AGENDA
REGULAR MEETING OF THE BIRMINGHAM PLANNING BOARD
WEDNESDAY JANUARY 28, 2026 – 7:30 PM
151 MARTIN ST., CITY COMMISSION ROOM 205, BIRMINGHAM MI*

SUBJECT: 600 N. Old Woodward Suites 101 & 203 – Old World Pizzeria – Special Land Use Permit, Final Site Plan & Design Review

SUBJECT: 325 S. Eton Street – District Lofts Phase 3 – New Mixed Use Four Story Building
– Final Site Plan & Design Review

H10 Overall Architectural Site Plan
 A005 SCALE: 1" = 20.0'

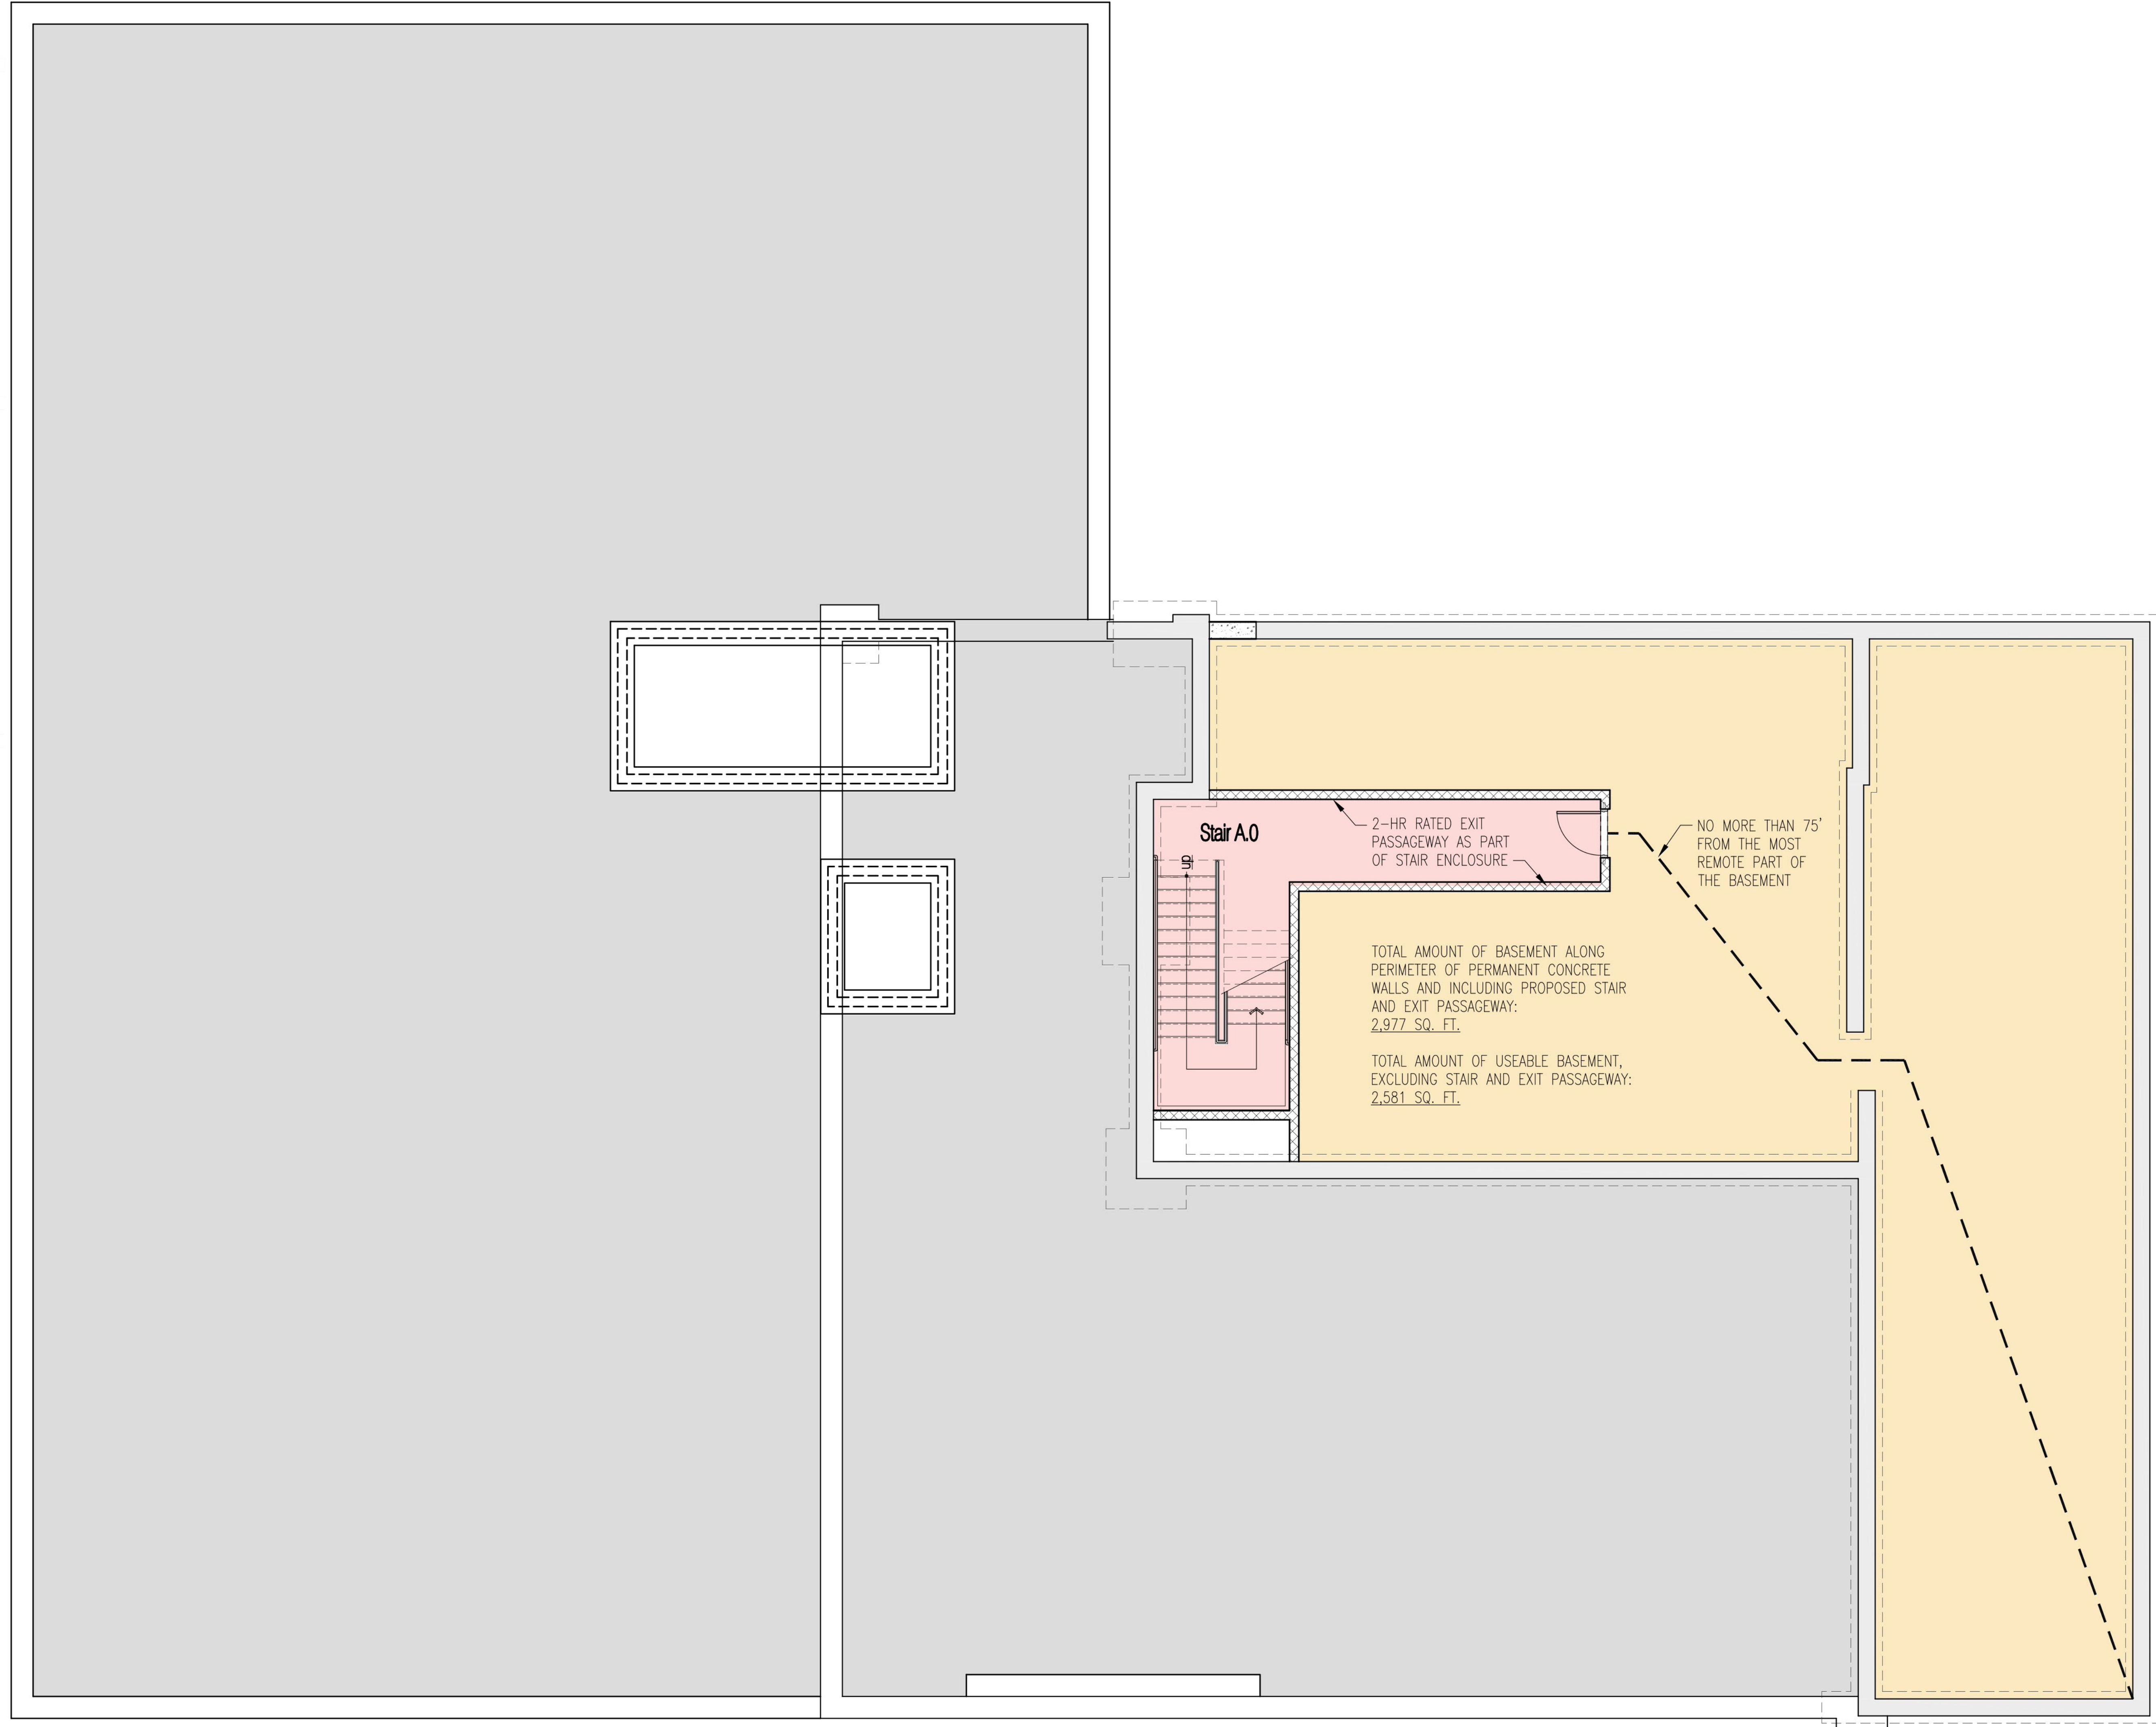
The applicant satisfies the parking requirement by 20 parking spaces on-site based on uses indicated in the submitted plans. There is an opportunity to request an additional 12 on-street parking spaces along Villa from City Commission, however the applicant does not intend to pursue such spaces at this time. **Staff would like to note that the applicant has indicated 6,600 SF for the first floor commercial space with three tenant spaces as either an office or retail use. If these spaces are filled with uses such as a salon or restaurant, the parking requirement for the entire site will increase due to different parking requirements of the uses. An excess of 20 spaces may not be adequate for highly intensive parking uses such as a salon or restaurant in all three commercial spaces.**

It does not appear as though the applicant is proposing two new loading spaces for the development. Rather, it appears as though they are suggesting that one new loading space be designated and the other required loading space be absorbed by one of the two existing loading spaces. The new proposed loading space on the north side of the development in the parking area is not a preferred condition. The Planning Department would like to suggest that the new development would not need to provide two *new* loading areas for the new development, but rather demonstrate that two loading spaces are available for use on the broader site. **The Planning Board may wish to discuss this determination.**

Another update from their 2021 approval is the installation of a crash gate along the current access drive that prevents through traffic from Villa to Eton on the site. When the permits were issued for the gate in 2025, the applicant explained that it had become a safety concern for the residents of the site when the new restaurant was opened. The new site plans do not reflect a gate. **The Planning Board may wish to request that the applicant explain whether or not the gate would remain in the new site, and require them to update the plans accordingly.**

Sheet No.:
A110
FIRST LEVEL - FLOOR PLAN

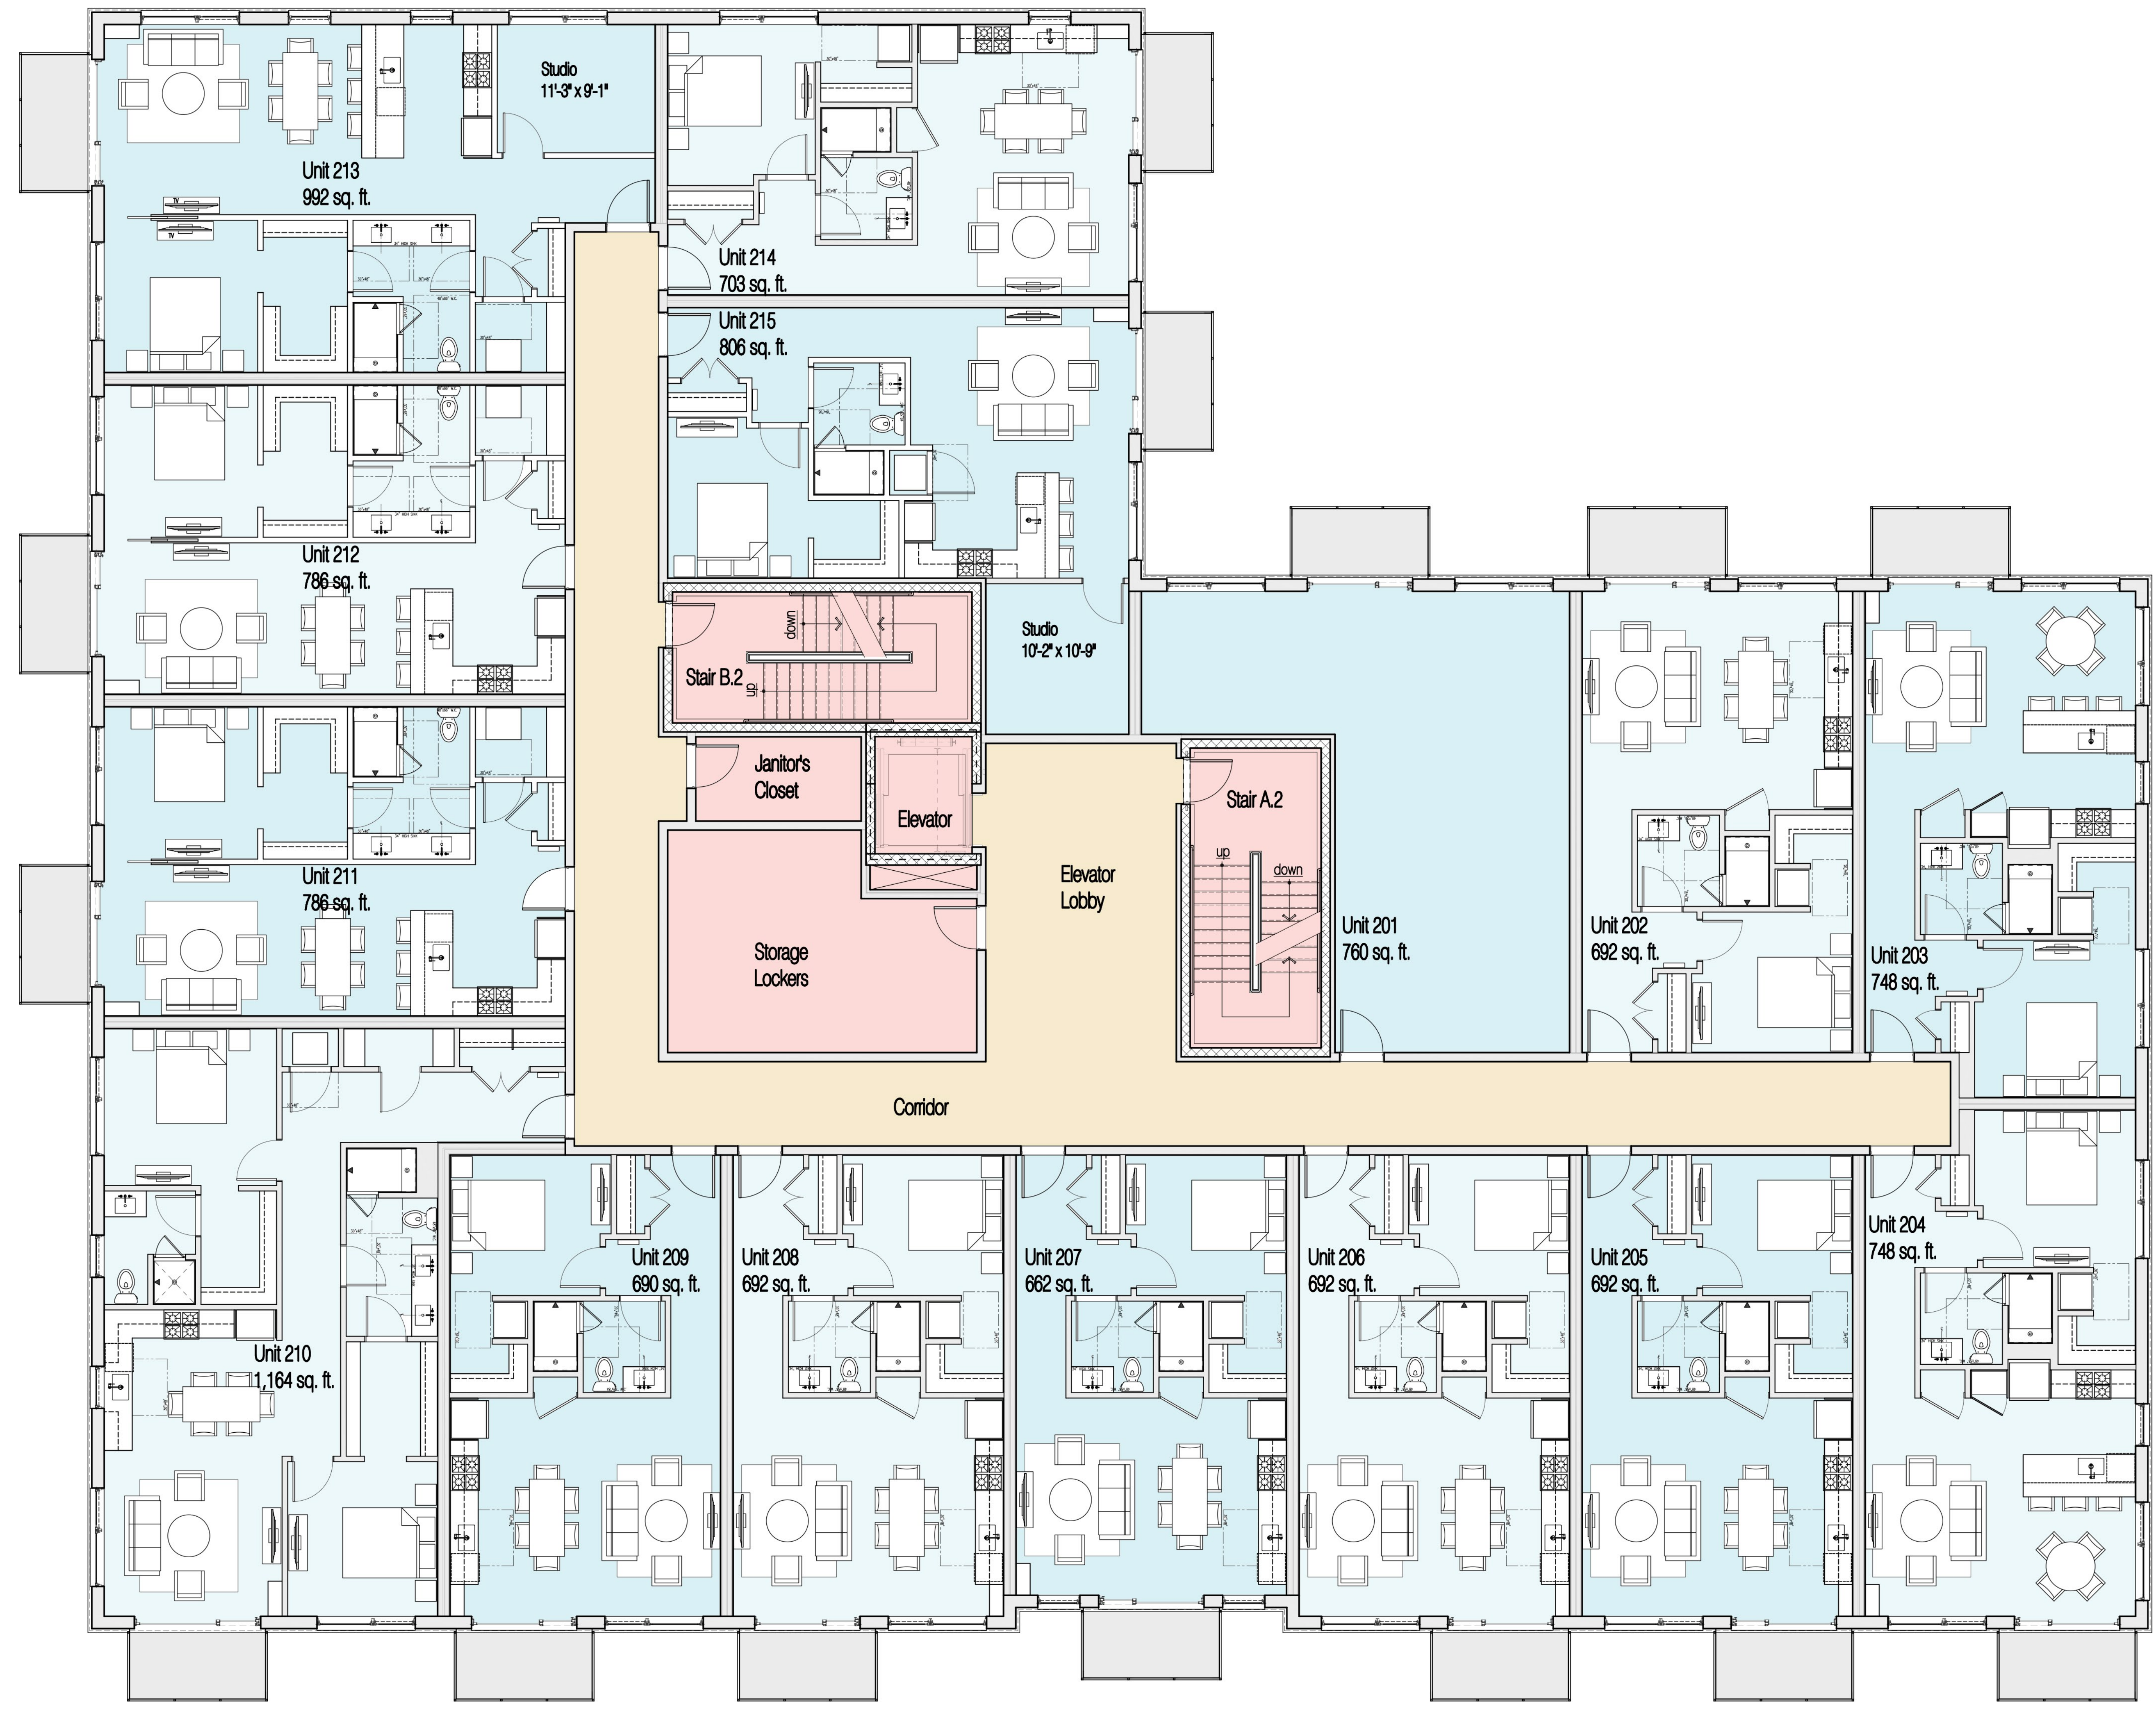
The applicant must submit complete floor plans indicating the number of bedrooms for all units in order to verify the minimum lot area per unit requirement. Units 101-105, 201, 301, and 401 do not currently have verifiable bedroom plans.

from finished floor to finished ceiling for the 1st floor in the MX zone. The plans appear to satisfy this requirement from the exterior elevation, however interior plans have not been included in the final site plan review for verification. **Building plans submitted must verify a first floor ceiling height of 12 feet measured from finished floor to finished ceiling.**
